Response to AER Information Request – Sydney CBD RIT-D Dispute

The issue in dispute and a summary of our response

The figure below illustrates how the Sydney CBD (shown in red) area sits within the wider Inner Sydney area (shown in green). The red area corresponds to the Sydney CBD network area as specified in Figure 1 of the FPAR.

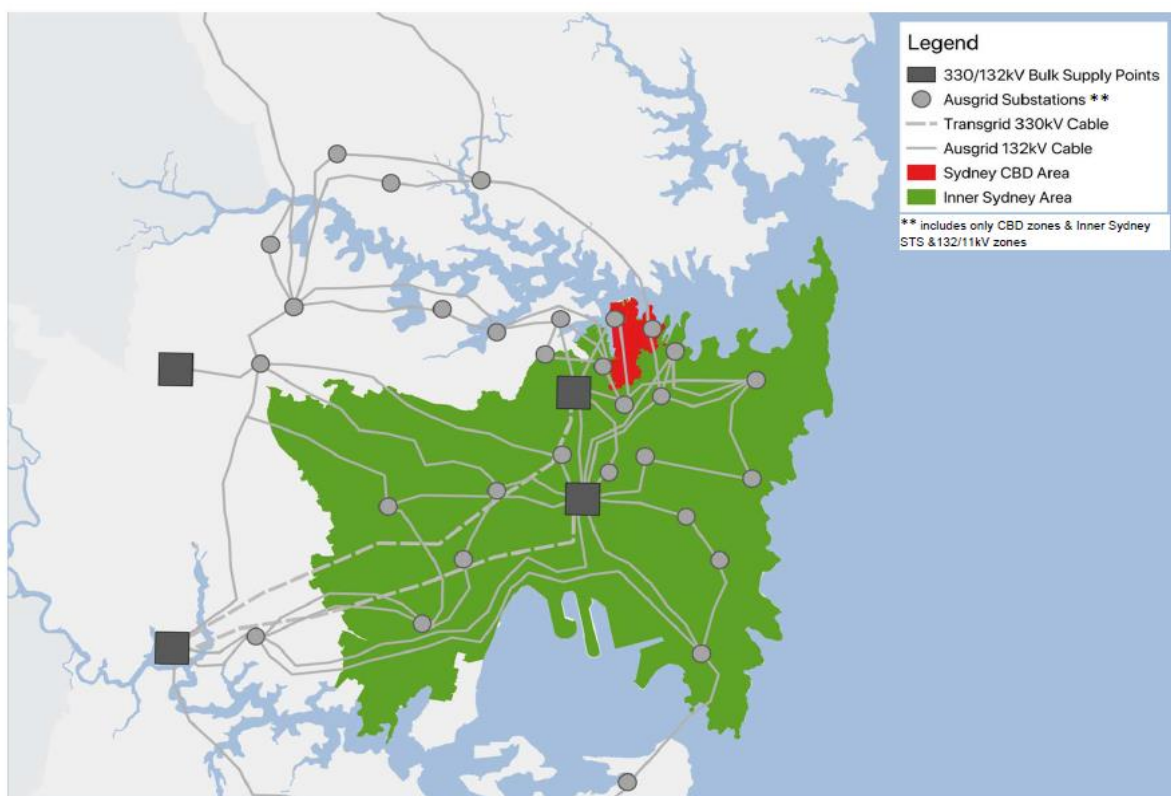
The underlying assessment and application to reach the \$170/kWh VCR figure as the central scenario in the Sydney CBD RIT-D. This includes a breakdown of customer demographics, including the types of the customers supplied by the two zone substations, their load requirements and annual energy consumption, within the Sydney CBD network area as specified in Figure 1 of the FPAR.

We note that the two areas serve fundamentally different customer bases – in particular:

- while there is a roughly even split between business and residential customer meters ('NMI's') in the CBD, business customers are responsible for approximately 97 per cent of the current annual electricity consumption (with residential customers making up the remaining 3 per cent); and
- in the wider Inner Sydney area, residential customers make up a far greater proportion of both NMIs (86 per cent compared to 44 per cent for the CBD) and annual consumption (24 per cent compared to 3 per cent for the CBD).

Comment on Figure 4 (FPAR):

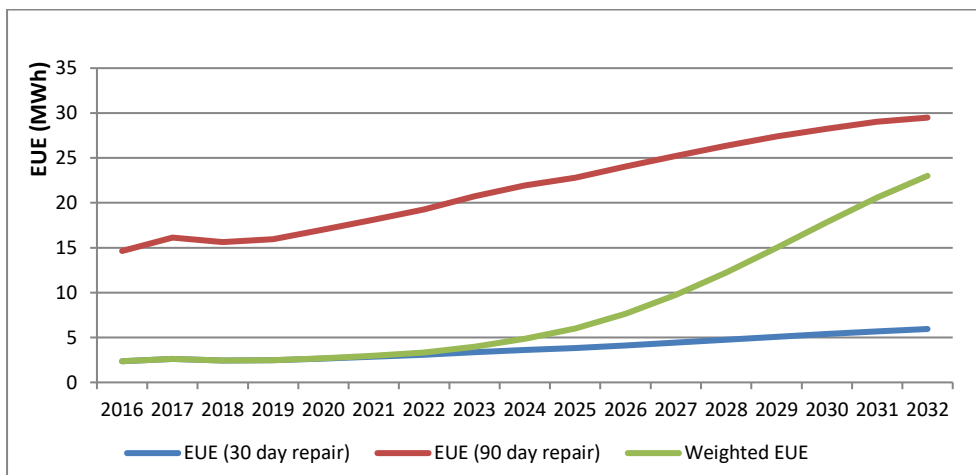
The model for the calculation of the unserved energy (USE). Include the assumptions that cause the change in rate of increase of unserved energy in 2023/24, as shown in Figure 4, and why the USE flattens off after 2035.

Change in rate:

As previously indicated, EUE is calculated for two scenarios that represents two contingency events as outlined below.

1. Contingency plan 1 (30 days): Ausgrid’s emergency switchroom is deployed and load is transferred from the failed switchboard.
2. Contingency plan 2 (90 days): The failed switchboard is removed and replaced with new switchgear because the deployment of the emergency switchroom is not feasible due to prior failures.

The above analysis of weightings results in the change in rate of increase of EUE around 2023/24. This can be illustrated as below.
